Foxground and Berry bypass

AUSTRAL PARK ROAD INTERCHANGE

JULY 2014

Austral Park Road Interchange

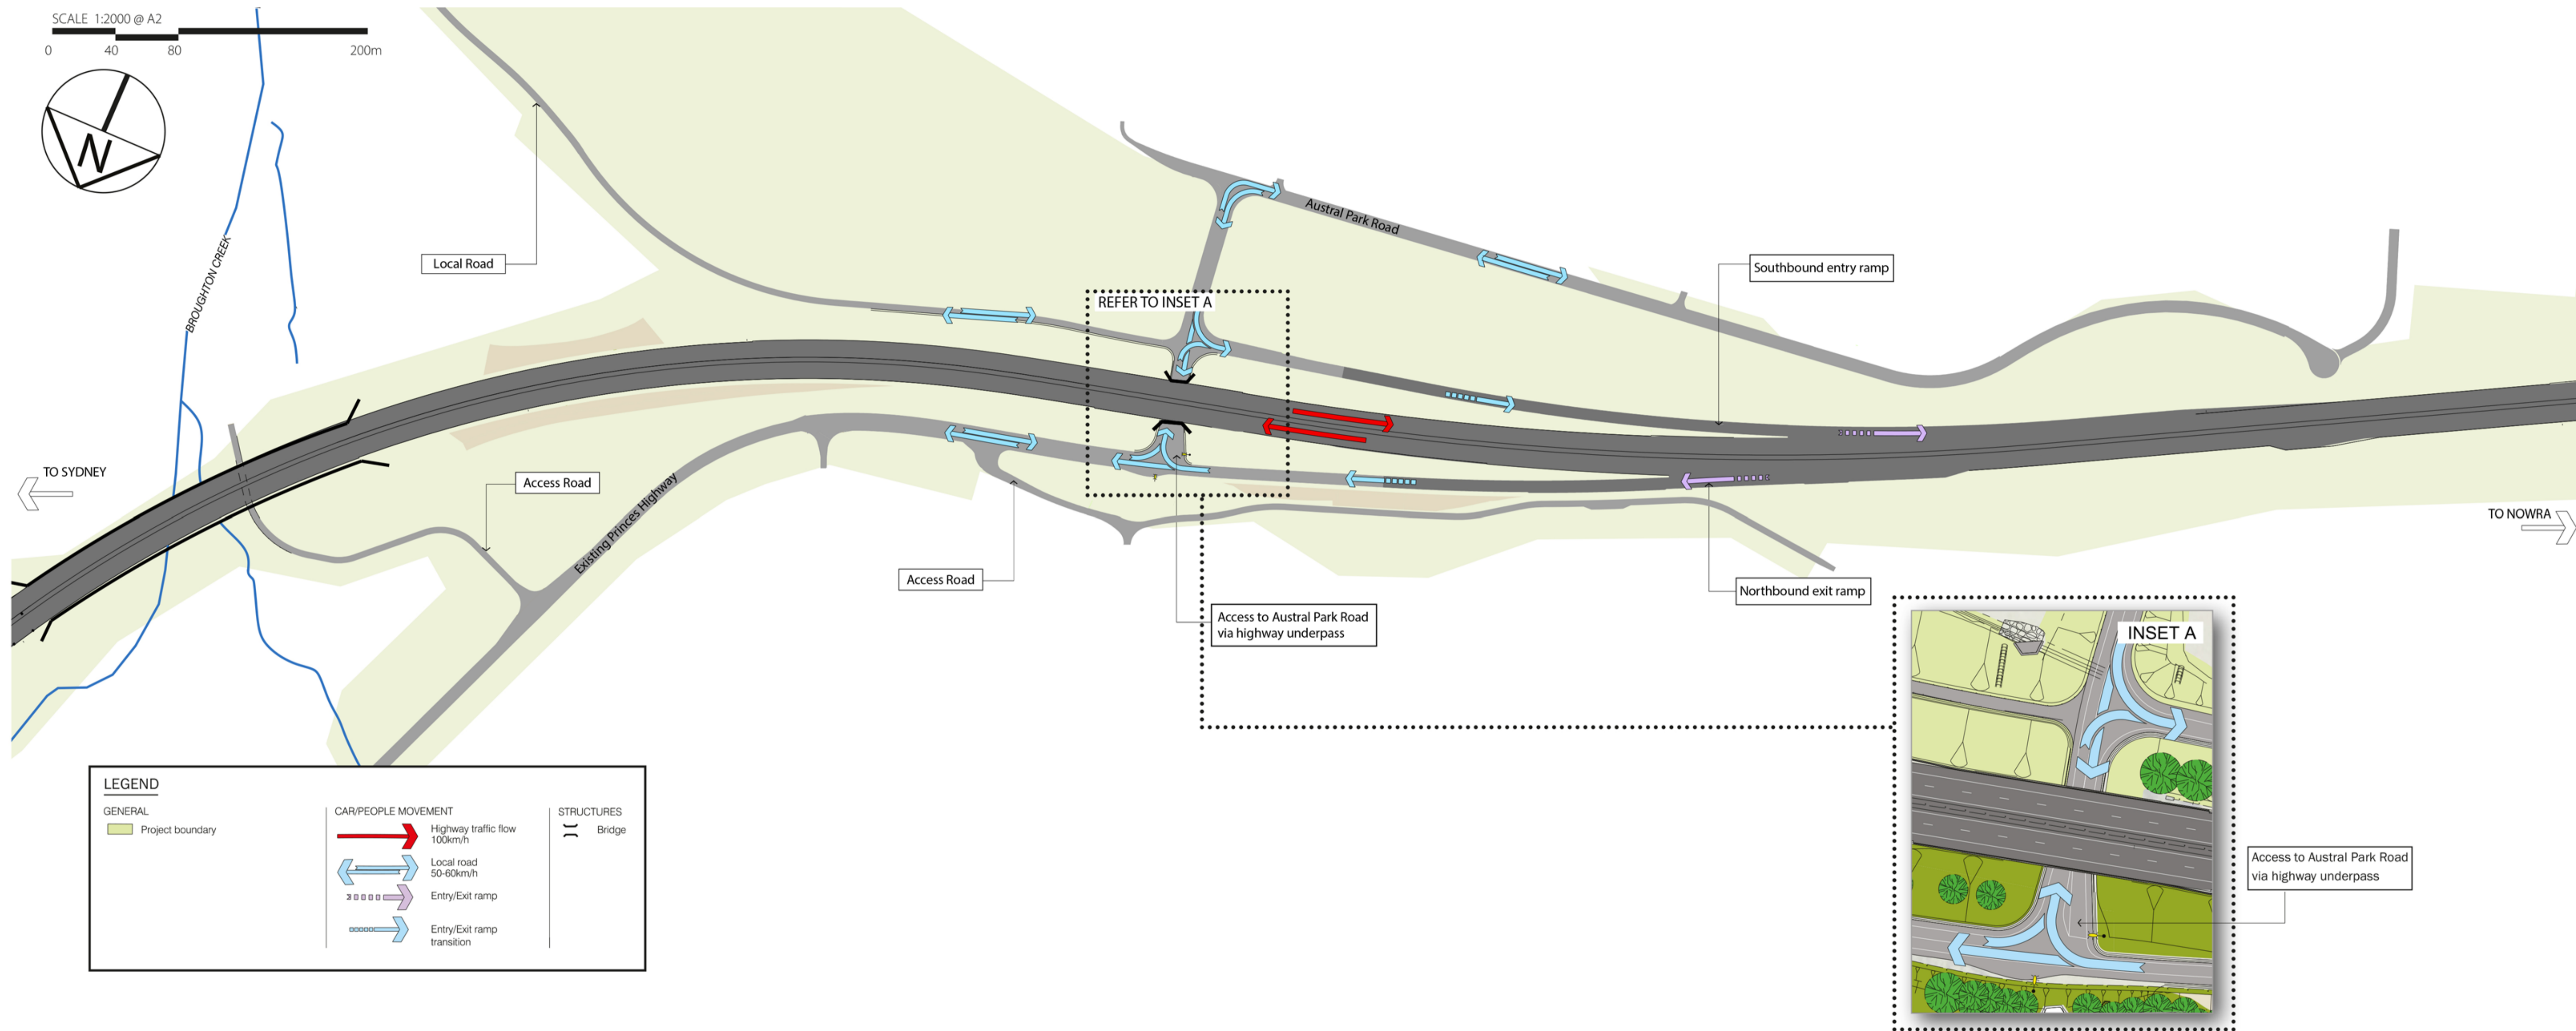
Changes from Approved Concept Design:

To improve safety for motorists a number of changes have been made:

- A new 33 metre long underpass will replace the previously planned overbridge.
- The bypass height has been raised by four metres to achieve clearance over the Austral Park Road extension.
- The new bypass, entry and exit ramps have been moved east by 16 metres.
- The northbound exit ramp has been moved south by 280 metres.
- Traffic will now pass under the main alignment and use the existing highway to the north to connect to Broughton Village, Foxground and Toolijooa Road.
- Private property accesses have been adjusted to improve safety and reduce travel for residents.
